Access Compliance Report

Public Rights-of-Way

(Curb Ramps)

Intersection ID: 29136	Main Street: DEATON_HILL_DR	Cross Street: FOREST_GROVE_CT	Location: W
ADA ID: 32E8DB9828F8	Ramp Type: PerpDiag	Initial Pass/Fail: Fail	Overall Compliance: No
Severity Score: 12.5			
Codes/Mitigation Info/Possible Solution		Field Measurements/Component Compliance

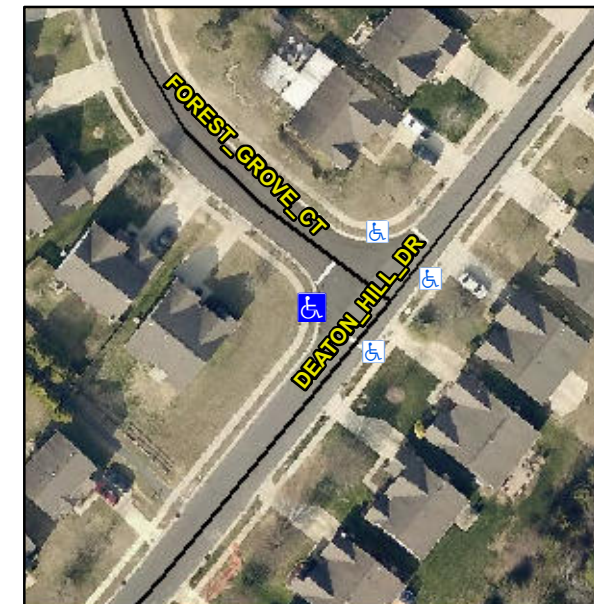
Remove & Replace Curb Ramp With Two New Directional Ramps or Equivalent.

R304.2.2

Compliance	Description	Data	Compliance	Description	Data
N/A	Ramp Length (in)	50.0	No	Ramp Slope (%)	9.2
Yes	Ramp Width (in)	48.0	Yes	Ramp XSlope (%)	0.3
N/A	Flare Type LT	N/A	N/A	Flare Type RT	N/A
N/A	Flare Slope LT (%)	N/A	N/A	Flare Slope RT (%)	N/A
N/A	Flare Traversable LT?	N/A	N/A	Flare Traversable RT?	N/A
N/A	Landing Length (in)	N/A	N/A	DWS Provided?	N/A
N/A	Landing Width (in)	N/A	N/A	DWS Contrast?	N/A
N/A	Landing Slope (%)	N/A	N/A	DWS Length (in)	N/A
N/A	Landing X Slope (%)	N/A	N/A	DWS Full Width?	N/A
N/A	Landing Curb? (Y/N)	N/A	N/A	DWS Offset (in)	N/A
N/A	Shared Landing?	N/A			
N/A	Gutter Ponding?	N/A	N/A	Gutter Slope (%)	N/A
N/A	Gutter Lip Ht (in)	N/A	N/A	Gutter X Slope (%)	N/A
N/A	Painted X Walk1?	No	N/A	Painted X Walk2?	No
	X Walk 1 Direction	To SE		X Walk 2 Direction	To NE
N/A	X Walk 1 Width (in)	N/A	N/A	X Walk 2 Width (in)	N/A
	X Walk 1 Slope (%)	6.1		X Walk 2 Slope (%)	7.1
	X Walk 1 X Slope (%)	5.7		X Walk 2 X Slope (%)	5.0
